Pentium® Pro Processor Specification Update

Release Date: June 1998

Order Number: 242689-029

The Pentium® Pro processor may contain design defects or errors known as errata which may cause the product to deviate from published specifications. Current characterized errata are documented in this Specification Update.

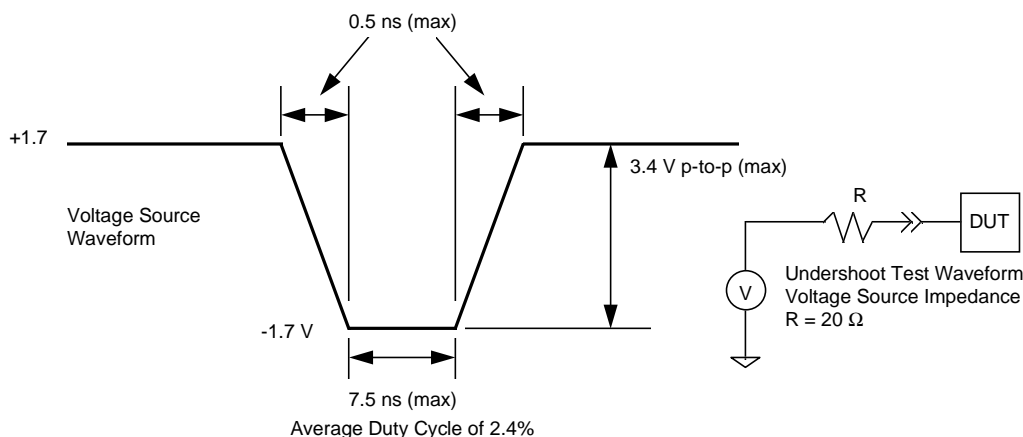
In the following table, “NI” implies that there are currently no known issues associated with mixing these steppings. An “X” implies that these steppings should not be used together in a system. A number indicates a known issue, and refers to the numbered list above. While there are no currently known issues associated with mixing cache sizes, Intel does not recommend or validate mixing processors with other cache sizes.

Pentium® Pro Processor Stepping	150-MHz B0	150-MHz C0	166-, 180-, 200-MHz sA0	166-, 180-, 200-MHz sA1	166-, 180-, 200-MHz sB1	OverDrive® Processor
150-MHz B0	3	3	1, 3	1, 3	1, 3	X
150-MHz C0	3	3	1, 3	1, 3	1, 3	X
166-, 180-, 200-MHz sA0	1, 3	1, 3	3	3	3	X
166-, 180-, 200-MHz sA1	1, 3	1, 3	3	NI	NI	X
166-, 180-, 200-MHz sB1	1, 3	1, 3	3	NI	NI	X
OverDrive® Processor	X	X	X	X	X	2

B. Expected Response

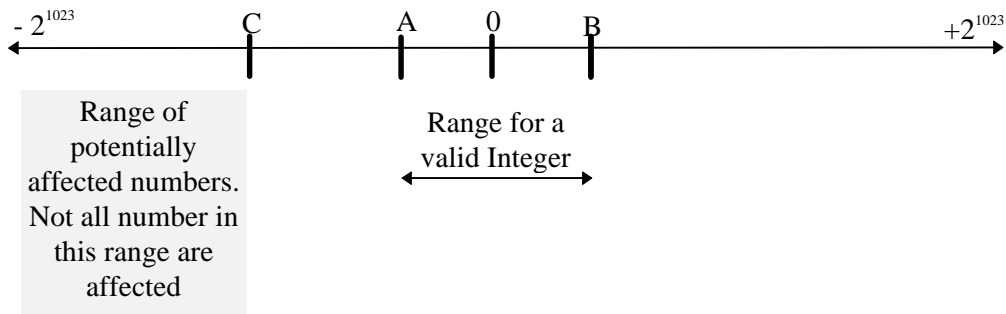
PROBLEM: On certain, large, negative, floating-point operands, and only in three of the four possible processor rounding modes, the instructions FIST[P] m16int and FIST[P] m32int do not detect that the operand is so large that it will not fit into the target data size. As a consequence, the expected Invalid Operation exception response for this situation is not correctly provided, nor is the Invalid Operation flag set in the Floating Point status word as specified in the *Intel Architecture Programmers Reference Manual, Volume 2*. Under the failing conditions, noted below, the precision exception (#PE) flag will also be incorrectly set. The erratum occurs only when all of the following conditions are met:

- The PE (precision error) bit the Floating Point status word is *set*.
- No exception handler is invoked.
- In the case of a FISTP instruction the Operand will have been popped from the floating point stack.

The expected processor response when the invalid operation exception is *masked* is:

- Return the MAXNEG value (8000h for FIST16 & 80000000h for FIST32) to memory.
- The IE (Invalid Operation) bit in the Floating Point status word is *set* to flag the overflow.
- The PE (precision error) bit the Floating Point status word is *not set*.

Figure 4-3. Stack Switch on a Call to a Different Privilege Level

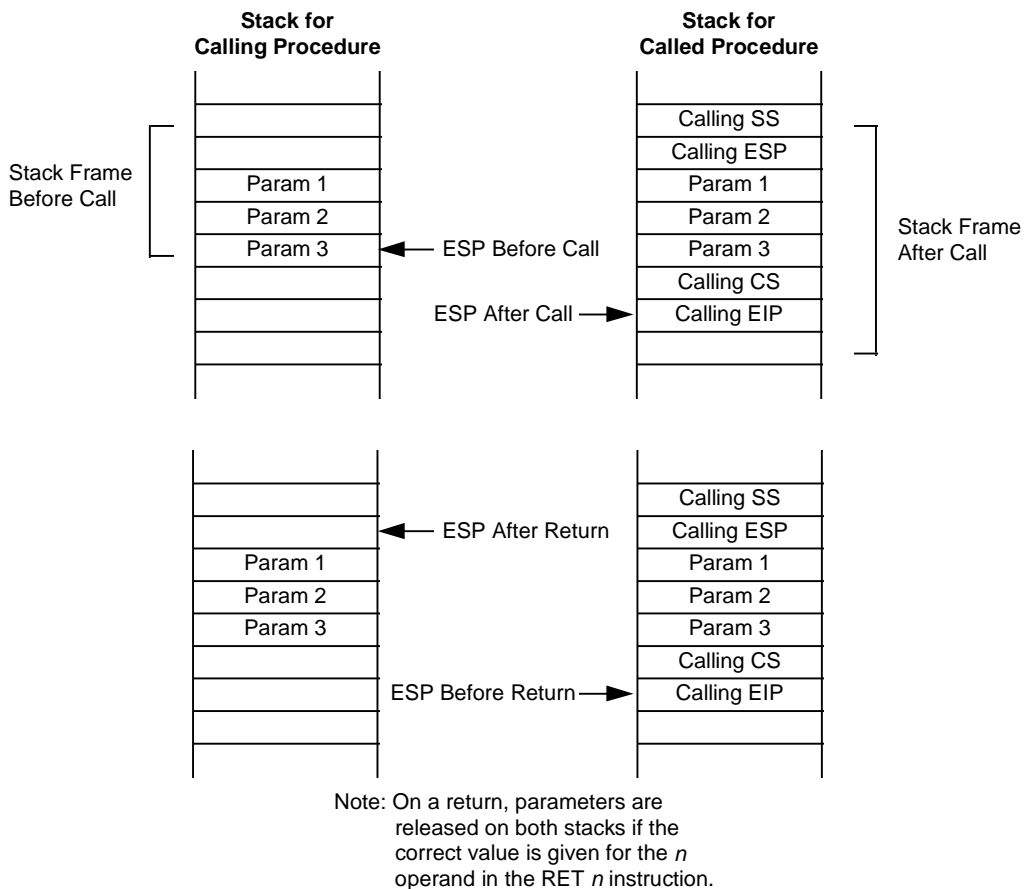
When making a call to a more privileged protection level, the processor does the following (see Figure 4-3):

4. Restores the SS and ESP registers to their values prior to the call, which causes a switch back to the stack of the calling procedure.
5. (If the RET instruction has an optional n argument.) Increments the stack pointer by the number of bytes specified with the n operand to release parameters from the stack (see explanation in step 3).

6. Resumes execution of the calling procedure.

Figure 4-4. Stack Usage on Transfers to Interrupt and Exception Handling Routines

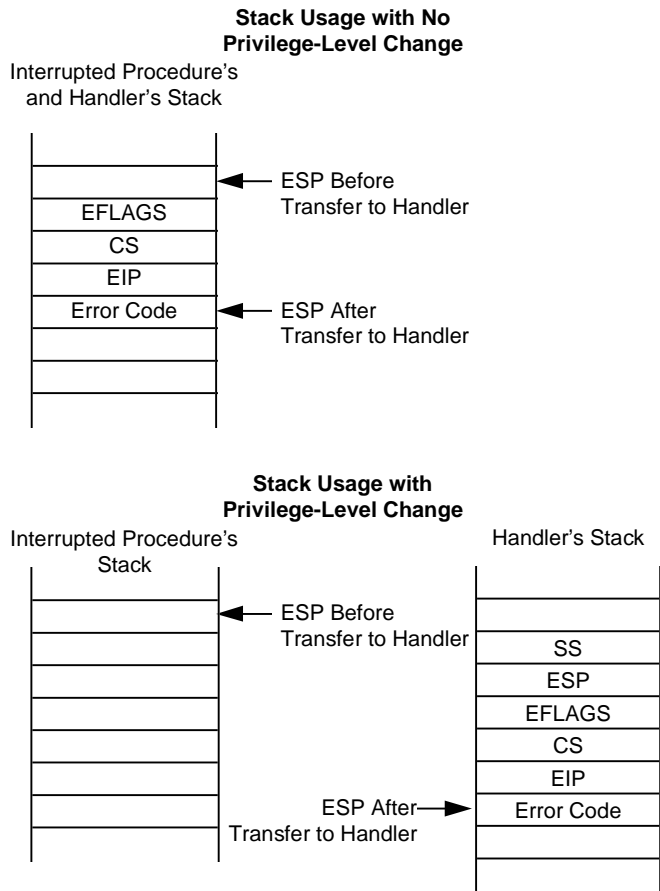
If no stack switch occurs, the processor does the following when calling an interrupt or exception handler (see Figure 44):

When executing a return from an interrupt or exception handler from a different privilege level than the interrupted procedure, the processor performs these actions:

1. Performs a privilege check.
2. Restores the CS and EIP registers to their values prior to the interrupt or exception.
3. Restores the EFLAGS register.
4. Restores the SS and ESP registers to their values prior to the interrupt or exception, resulting in a stack switch back to the stack of the interrupted procedure.
5. Resumes execution of the interrupted procedure.
